**ADDENDUM NUMBER ONE**

March 30, 2016

PROJECT: Arena Seating Replacement  
**FREEDOM HALL CIVIC CENTER**  
Johnson City, Tennessee  
Johnson City Bid No. 6022

ARENA SEATING REPLACEMENT  
FREEDOM HALL CIVIC CENTER  
JOHNSON CITY, TENNESSEE

SEATING SECTIONS PLAN  
SCALE 3/32" = 1'-0"

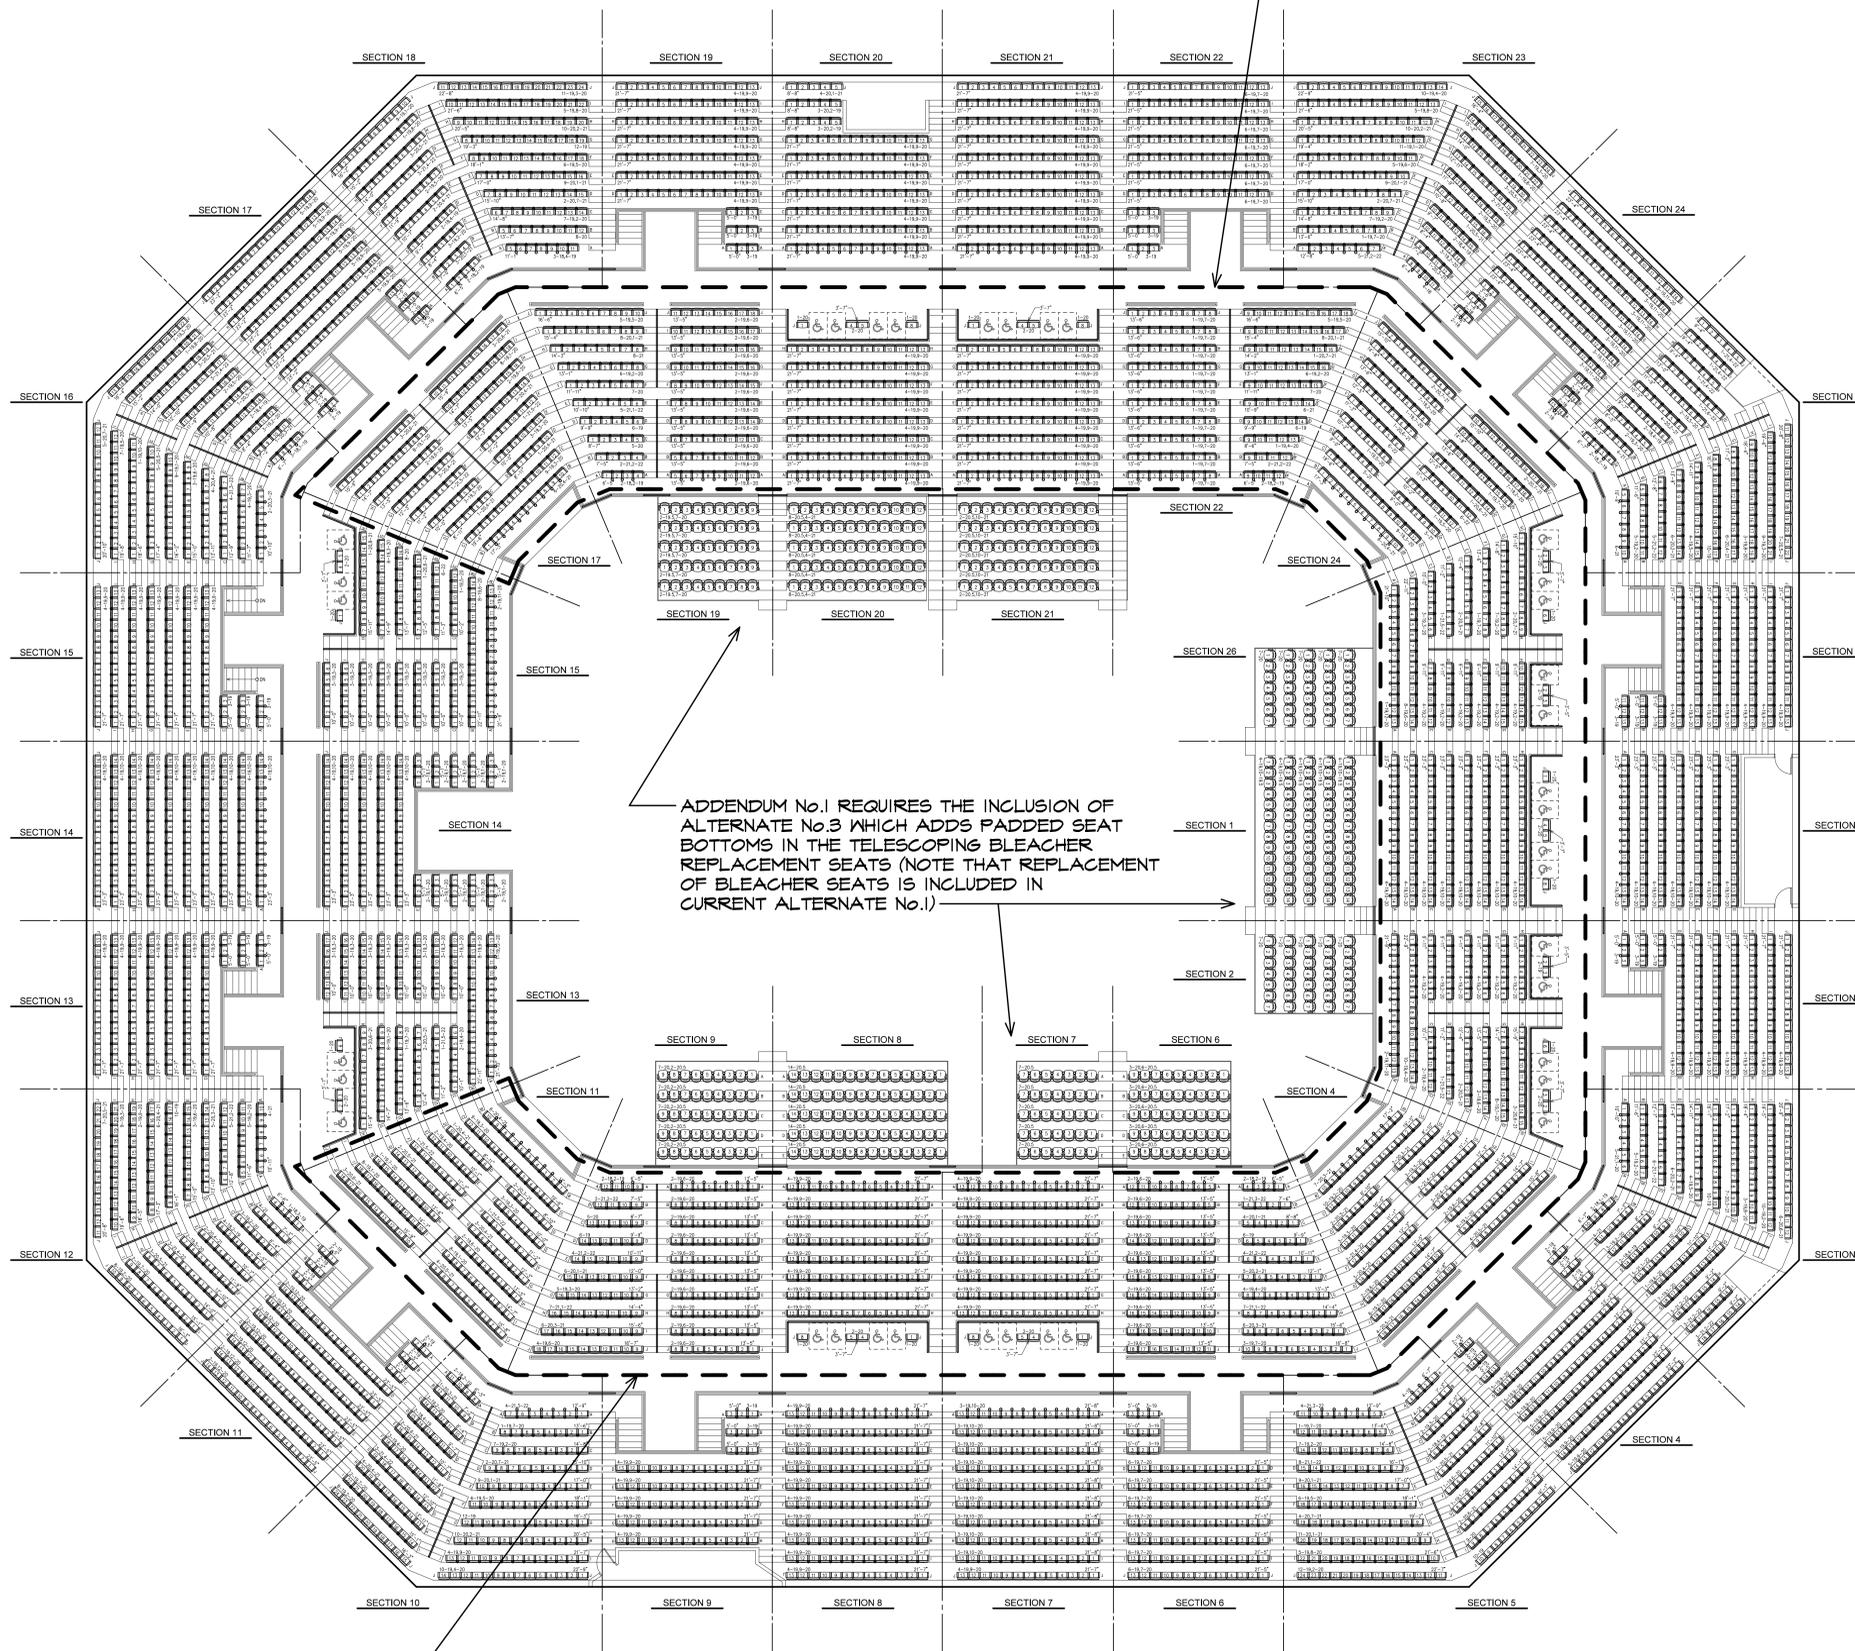
- ADD 1-5 Include Alternate No. 2 which will add padded seat bottom inserts as follows: All seats in the seating sections herein identified in the lower “bowl” (between the Concourse / Vomitory mid-arena perimeter aisle and the arena floor) are to have not only padded back inserts, but shall also have similar padded seat bottom inserts. This includes the lower “bowl” seats in Seating Sections 1, 2, 4, 6, 7, 8, 9, 11, 17, 19, 20, 21, 22, 24, and 25 as identified on attached Drawing A1.2.1. This includes Handicap Platform seats.

ADDENDUM No.1 REQUIRES THE INCLUSION OF ALTERNATE No.2 WHICH ADDS PADDED SEAT BOTTOMS TO SECTIONS OF FIXED SEATS ENCLOSED BY HEAVY DASHED LINE (PADDED SEAT BACKS ARE CURRENTLY REQUIRED)

ADDENDUM No.1 REQUIRES THE INCLUSION OF ALTERNATE No.3 WHICH ADDS PADDED SEAT BOTTOMS IN THE TELESCOPING BLEACHER REPLACEMENT SEATS (NOTE THAT REPLACEMENT OF BLEACHER SEATS IS INCLUDED IN CURRENT ALTERNATE No.1)

ADDENDUM No.1 REQUIRES THE INCLUSION OF ALTERNATE No.2 WHICH ADDS PADDED SEAT BOTTOMS TO SECTIONS OF FIXED SEATS ENCLOSED BY HEAVY DASHED LINE (PADDED SEAT BACKS ARE CURRENTLY REQUIRED)
